MEMORANDUM

DATE: October 13, 2020

SUBJECT: Final Design and Environmental Revalidation of SR-241/SR-91 Express Lanes Connector Project (ORA111207)

FIGURE 1

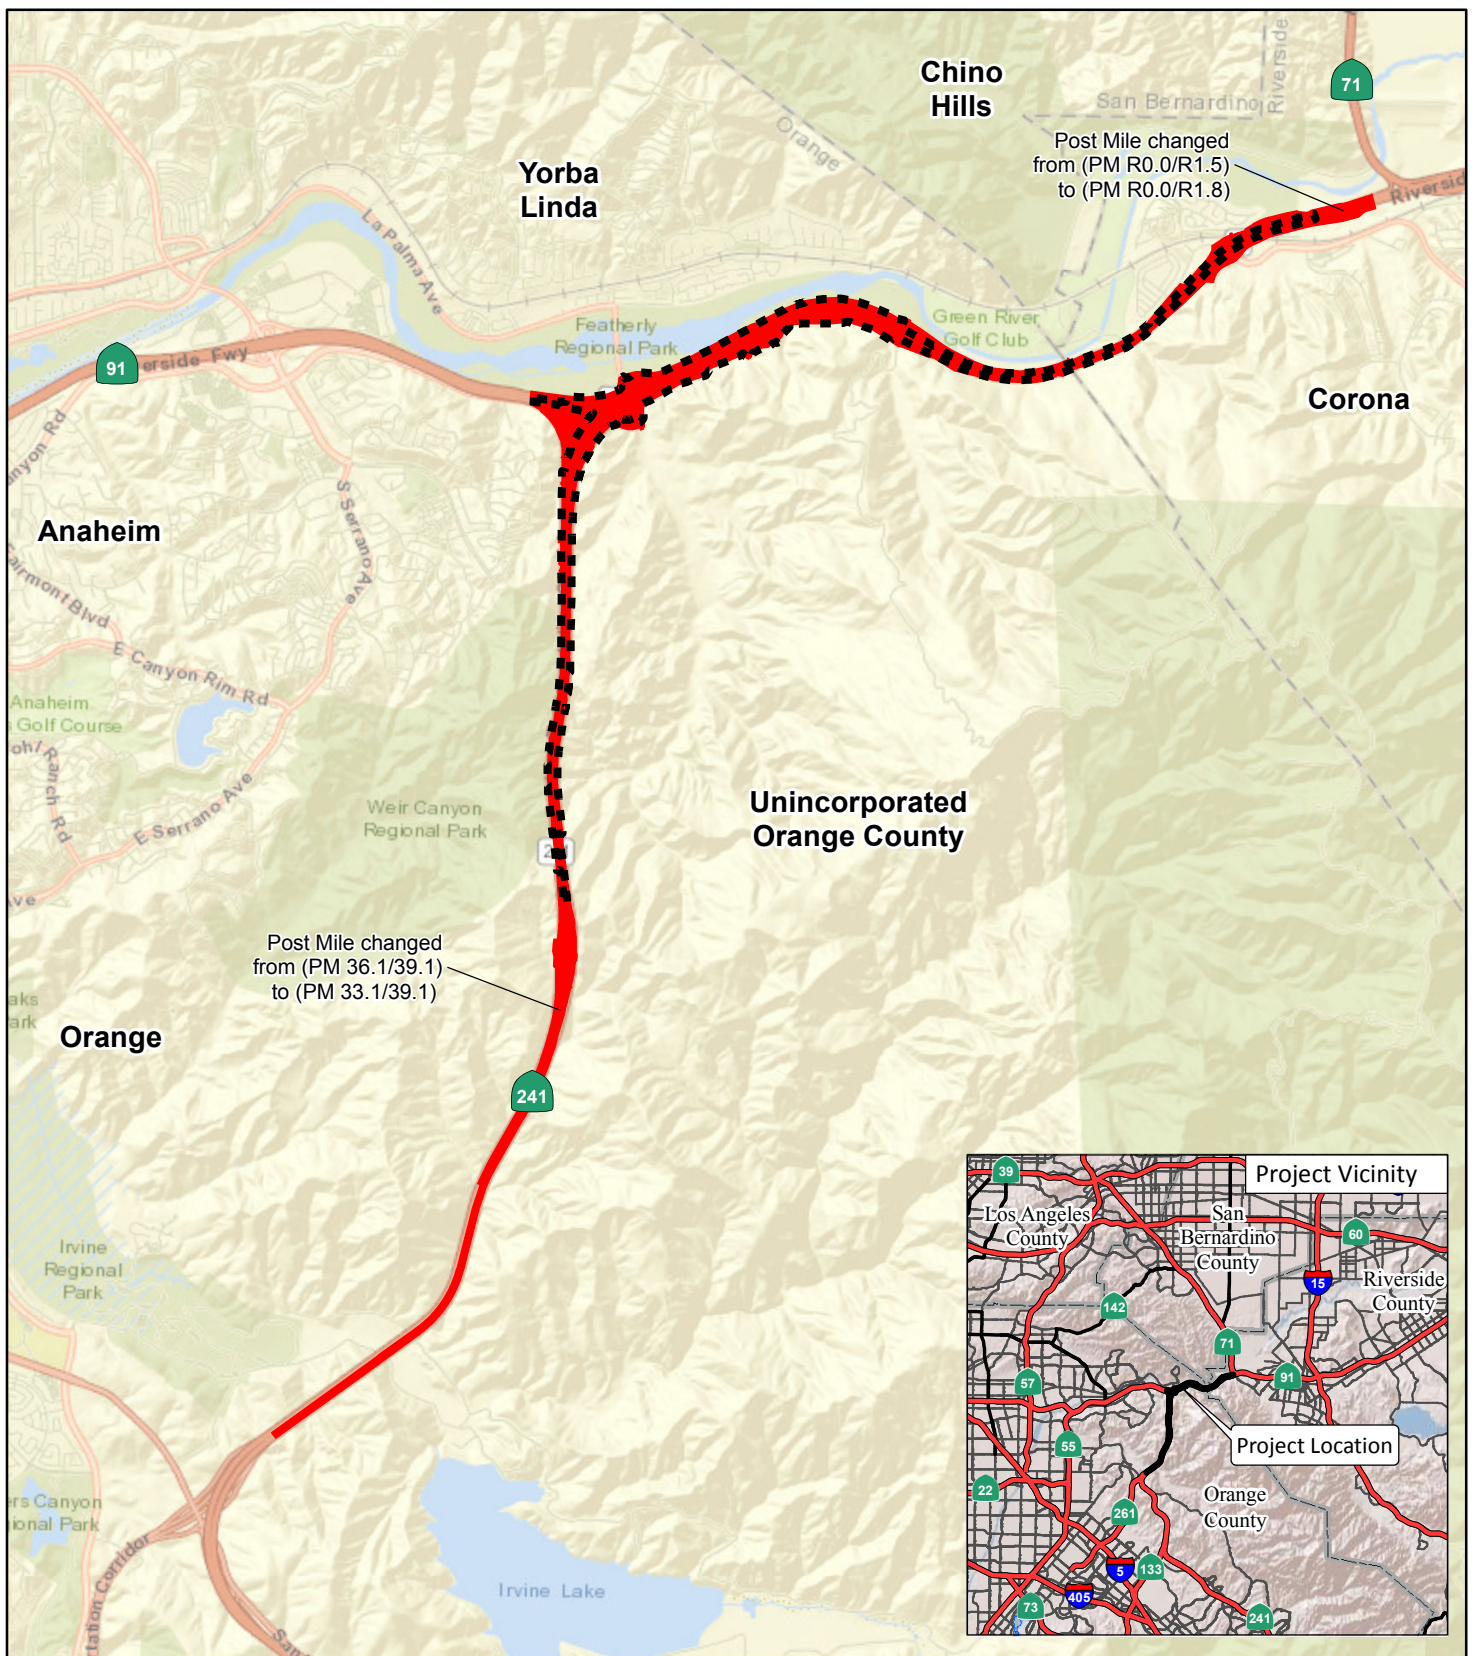
Post Mile Changes

The original limits of the Proposed Project encompass 12-ORA-241 (PM 36.1/39.1), 12-ORA-91 (R14.7/R18.9), and 08-RIV-91 (PM R0.0/R1.5). The revised limits for the Final Design of the Proposed

Project encompass **12-ORA-241 (PM 33.1/39.1)**, 12-ORA-91 (PM R14.7/R18.9), and **08-RIV-91 (PM R0.0/R1.8)**. Note: the changes in the post mile are bolded and underlined. Refer to Figure 1.

EXHIBIT 2 - GEOMETRIC APPROVAL DRAWING

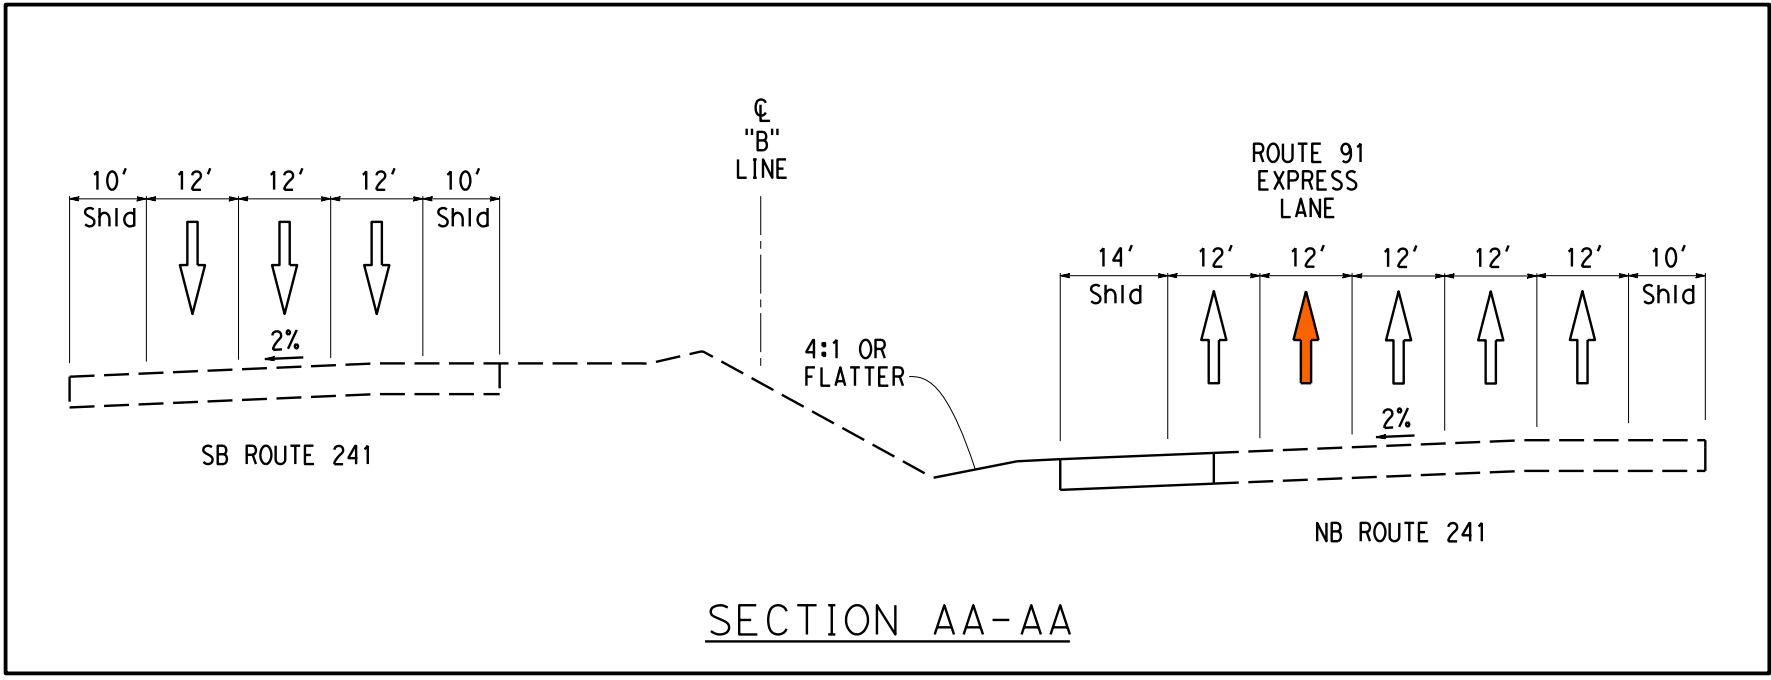
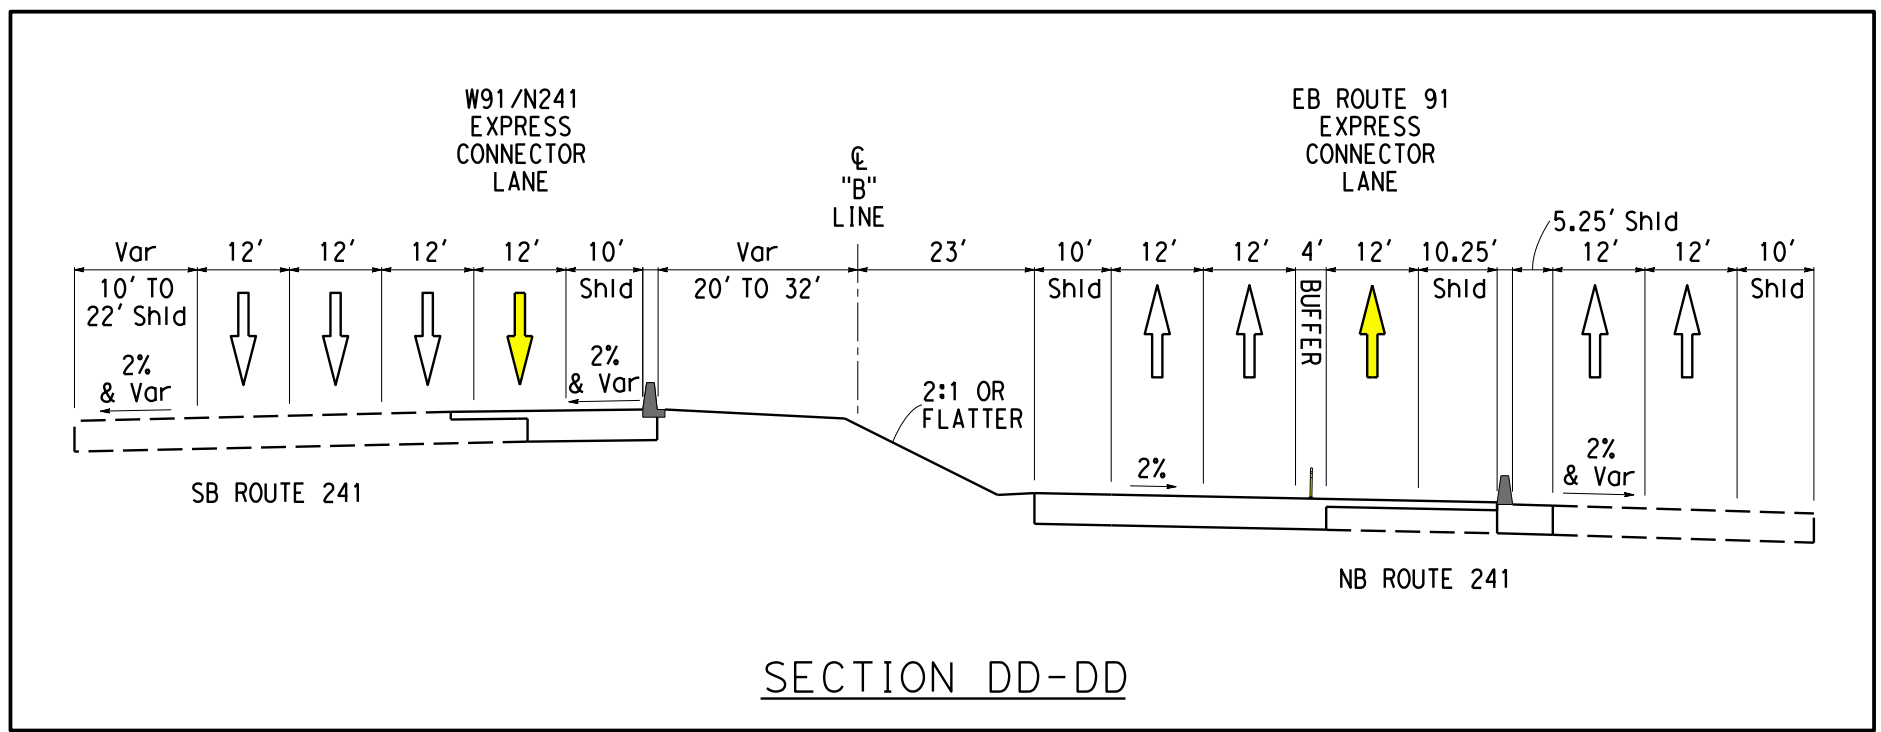
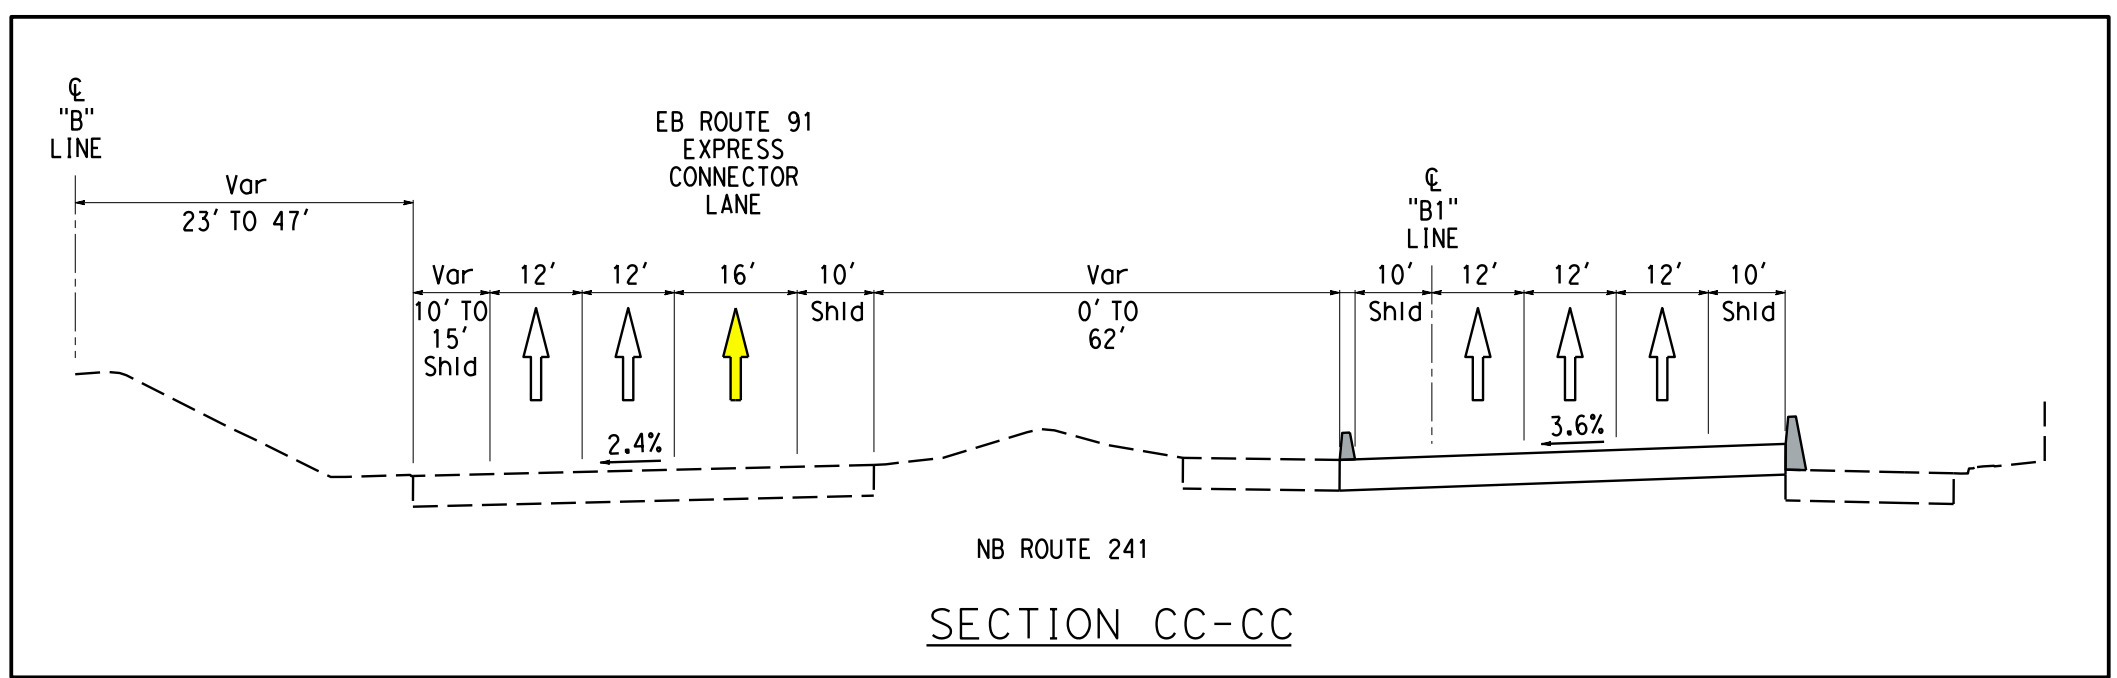
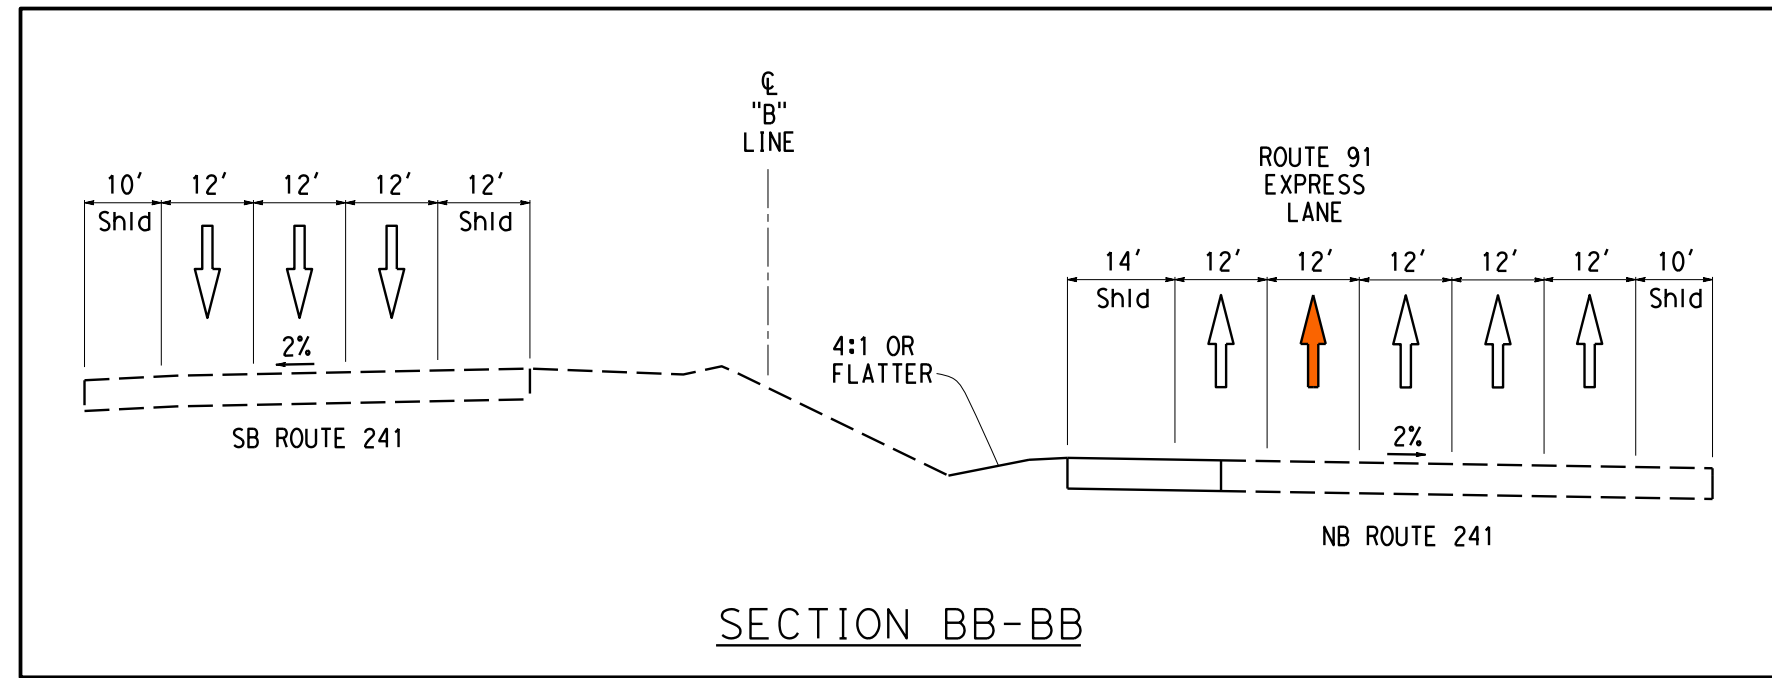
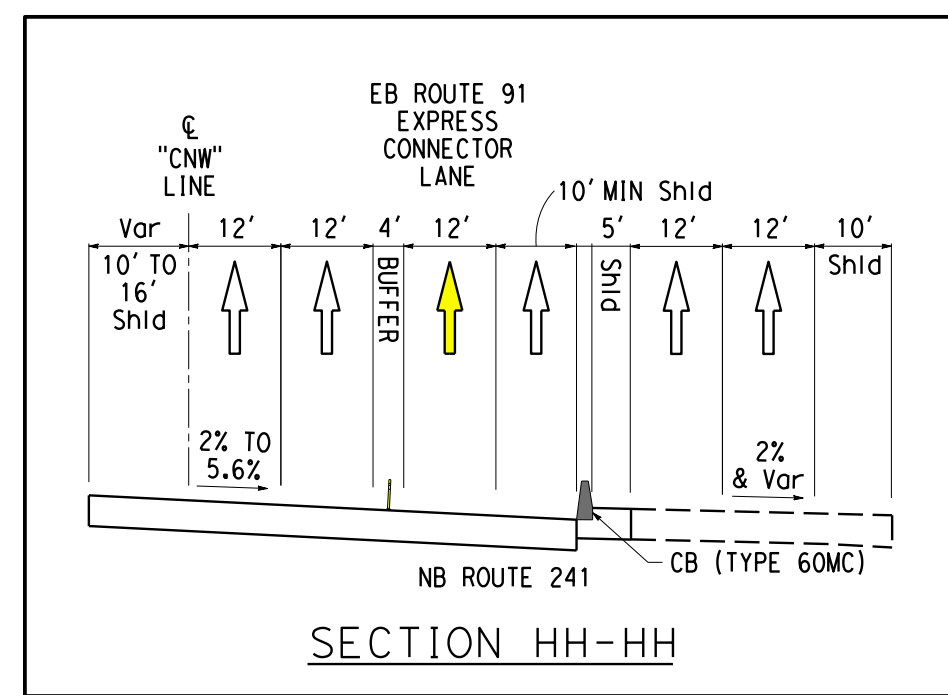
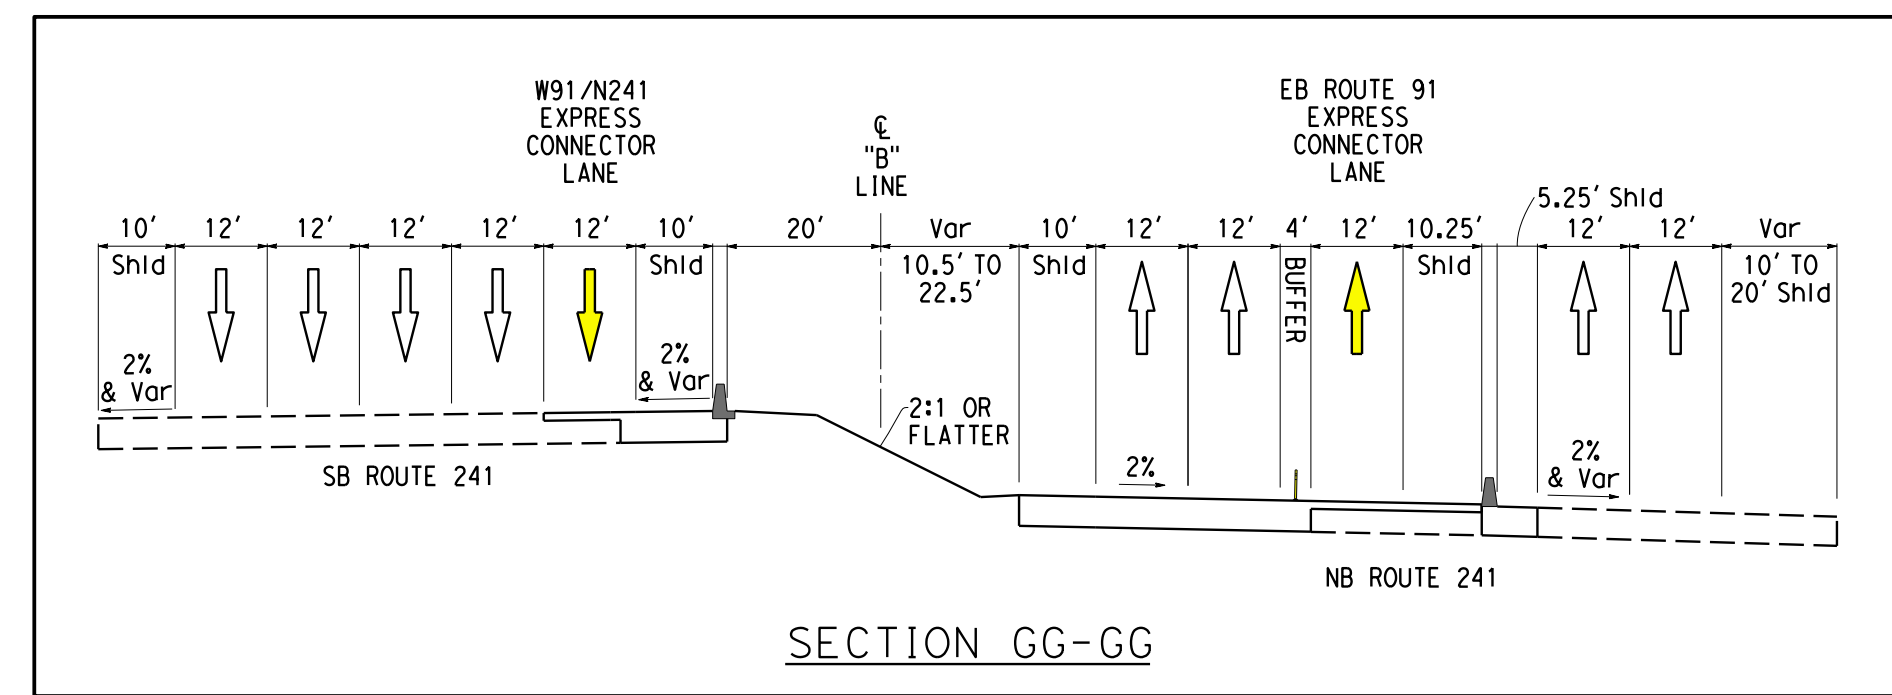
Lane Addition on SR-241 - New Impervious Pavement

The number of lanes provided south of Santiago Creek Bridge and at the SR 241/SR-91 express connector structure is the same as that included in the PA/ED Design and therefore no additional capacity or vehicle throughput would be provided by the design refinements. The Final Design would also reduce queueing on SR 241 and mitigate queue jumping within the Project limits. The addition of the five-lane cross section between Santiago Creek Bridge and the diverge point will provide traffic operational improvements providing additional signage and distance for vehicles to be aligned into the correct lanes.

While the Final Design of the Build Alternative would extend the fifth lane to begin at a location just north of the Santiago Creek Bridge on SR 241, providing an additional 3 mi as compared to the PA/ED design, the number of through lanes south of this point (three northbound lanes across Santiago Creek Bridge), and the lanes provided at the express lanes connector, and through lanes on SR-91 remains the same as that analyzed in the Final Supplemental EIR/EIS, which approved four existing general purposes lanes and one new express connector lane.

As described above, these design refinements do not constitute a capacity-increasing project. Refer to Figure 2.
